UNITED STATES
DEPARTMENT OF THE INTERIOR
BUREAU OF LAND MANAGEMENTNMOCD
ArtesiaFORM APPROVED
OMB NO. 1004-0137
Expires: January 31, 2018**SUNDRY NOTICES AND REPORTS ON WELLS**
*Do not use this form for proposals to drill or to re-enter an abandoned well. Use form 3160-3 (APD) for such proposals.***SUBMIT IN TRIPLICATE - Other instructions on page 2**5. Lease Serial No.
NMNM0506A
6. If Indian, Allottee or Tribe Name
7. If Unit or CA/Agreement, Name and/or No.
891000303X8. Well Name and No.
POKER LAKE UNIT 15 TWR 903H9. API Well No.
30-015-4545310. Field and Pool or Exploratory Area
WILDCAT11. County or Parish, State
EDDY COUNTY, NM

XTO Permian Operating, LLC requests permission change the formation from Cotton Draw Bone Spring South (Oil) to Purple Sage Wolfcamp (Gas).

DRILLING PLAN: BLM COMPLIANCE
(Supplement to BLM 3160-3)

PECOS DISTRICT DRILLING CONDITIONS OF APPROVAL

13-3/8" x 9-5/8" x 5-1/2" 10M RSH-2 Wellhead
Assembly, With T-EBS-F Tubing Head

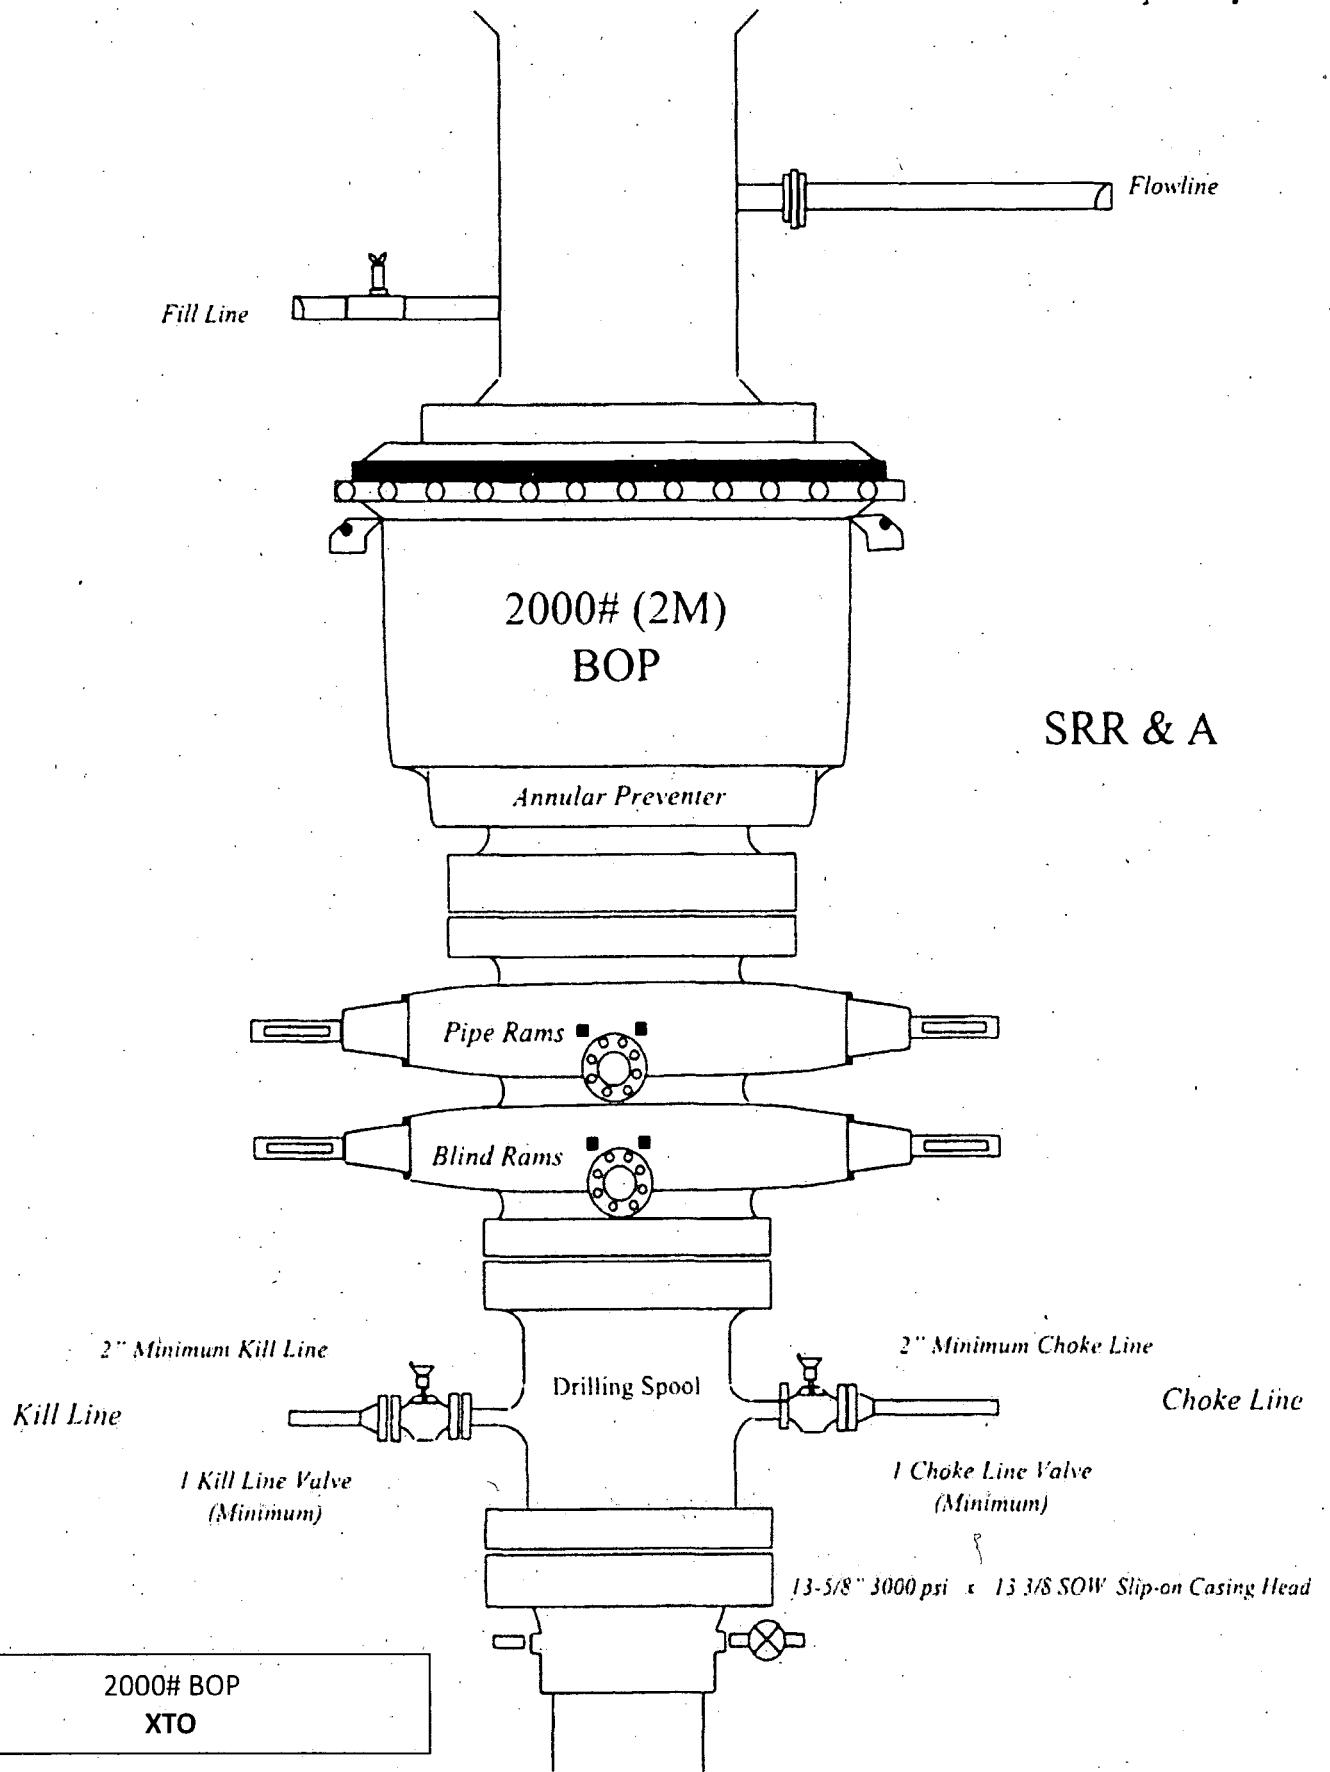
4. **Operator has proposed a multi-bowl wellhead assembly. This assembly will only be tested when installed on the 13-3/8 inch 1st intermediate casing. Minimum working pressure of the blowout preventer (BOP) and related equipment (BOPE) required for drilling below the 13-3/8 inch 1st intermediate casing shoe shall be 5000 (5M) psi.**

- a. Wellhead shall be installed by manufacturer's representatives, submit documentation with subsequent sundry.
 - b. If the welding is performed by a third party, the manufacturer's representative shall monitor the temperature to verify that it does not exceed the maximum temperature of the seal.

- c. Manufacturer representative shall install the test plug for the initial BOP test.
 - d. Operator shall perform the 9-5/8 inch 2nd intermediate casing integrity test to 70% of the casing burst. This will test the multi-bowl seals.

5000# BOP
XTO

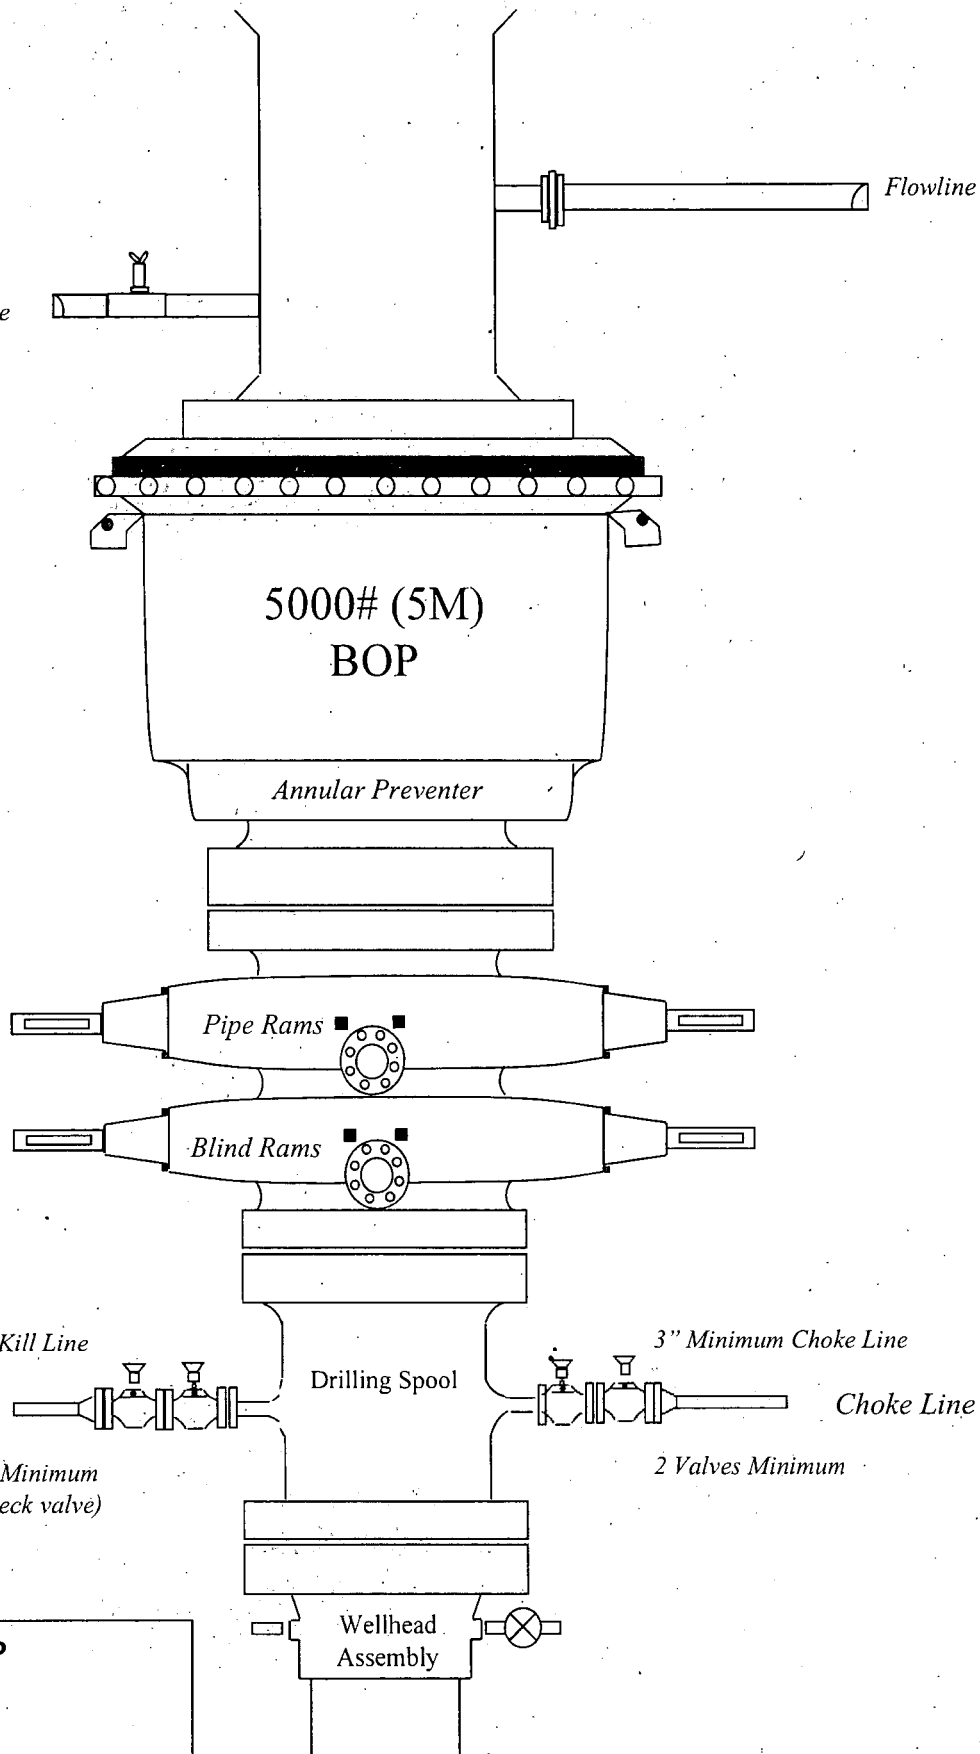
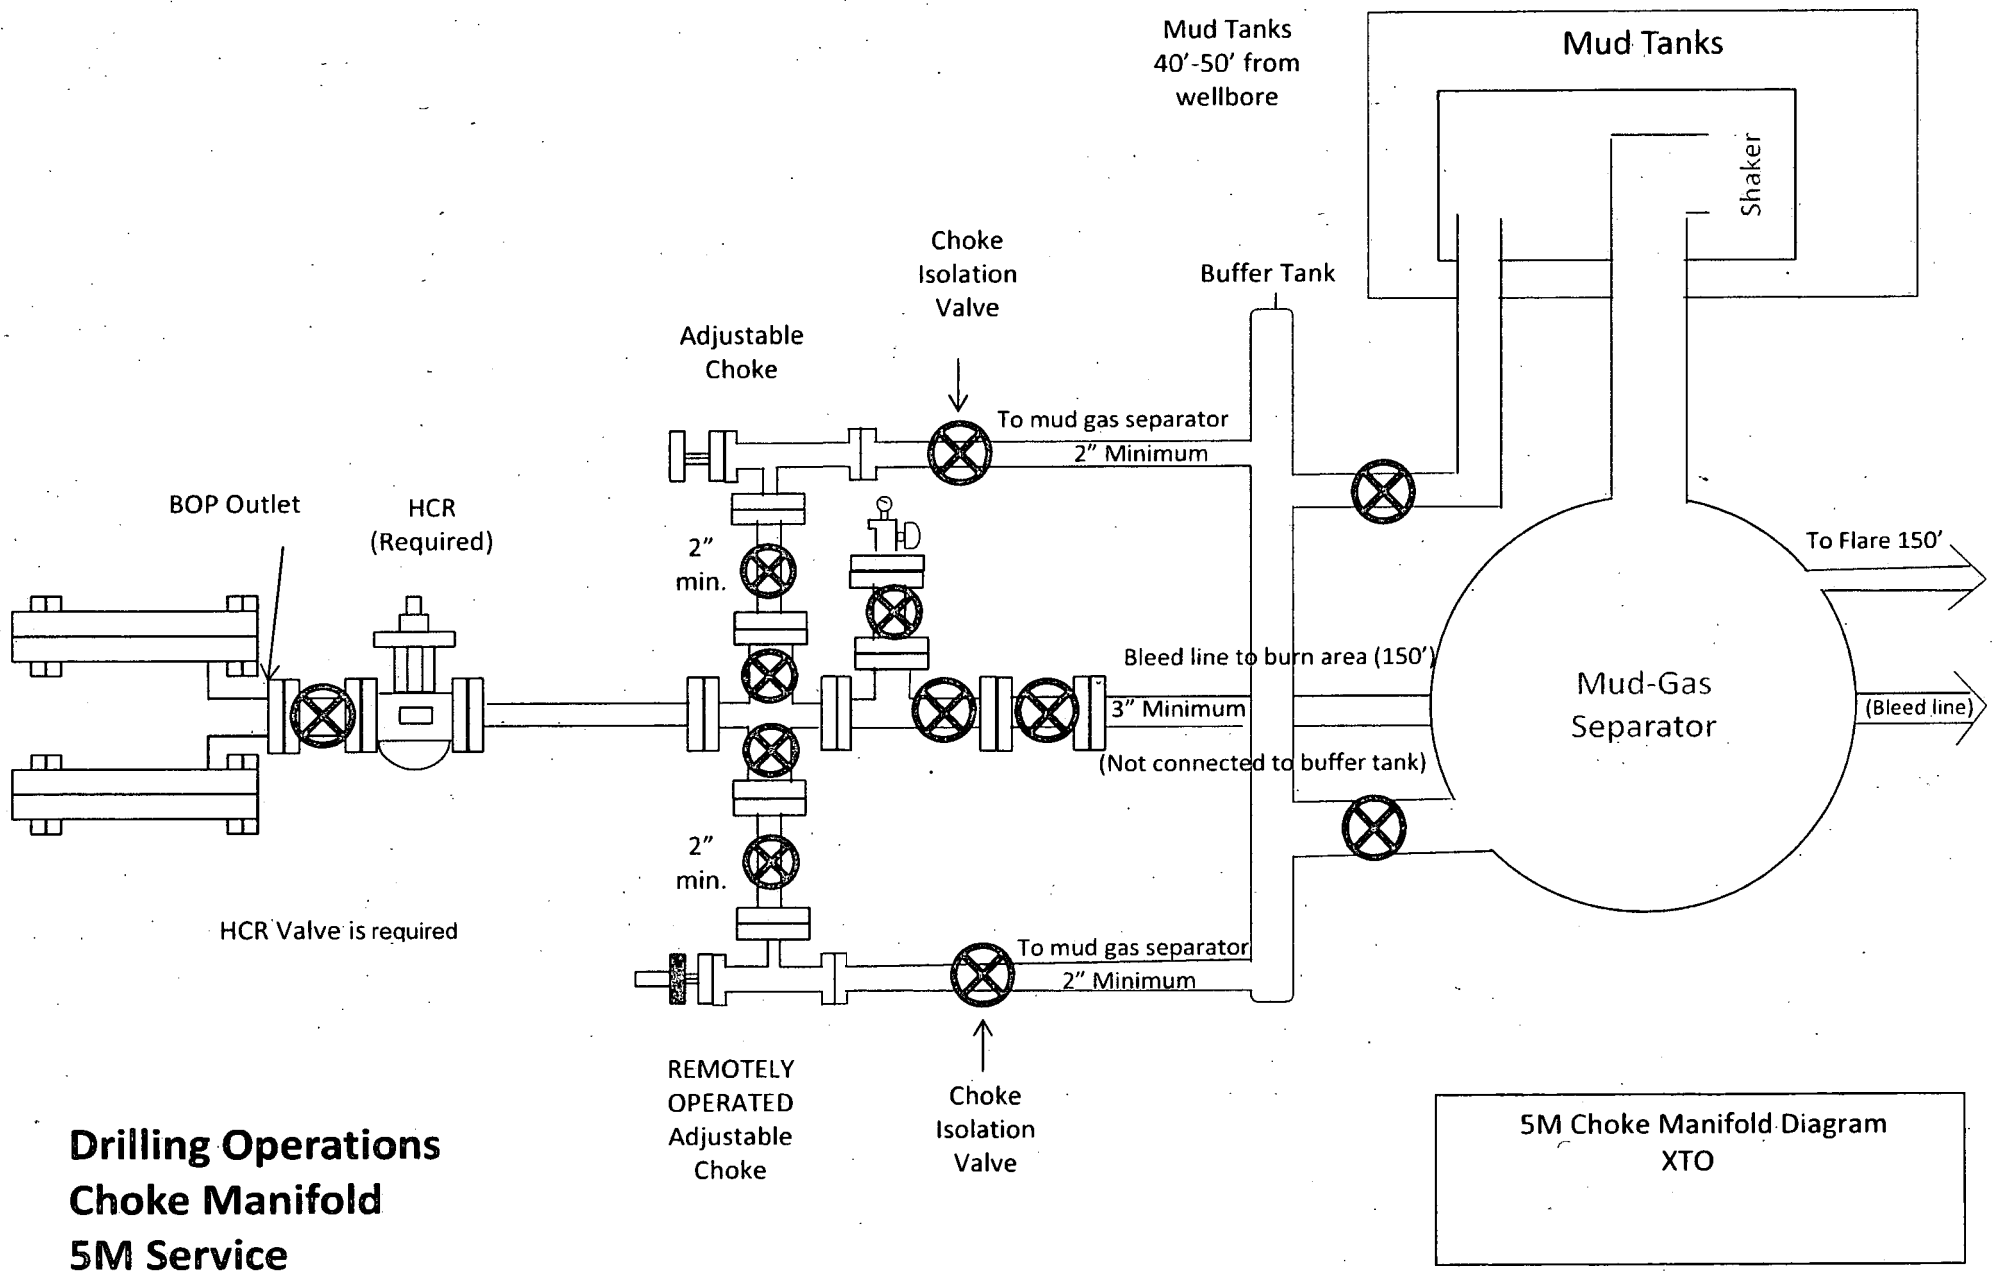
5M system requires an HCR valve, remote kill line and annular to match. The remote kill line is to be installed prior to testing the system and tested to stack pressure.
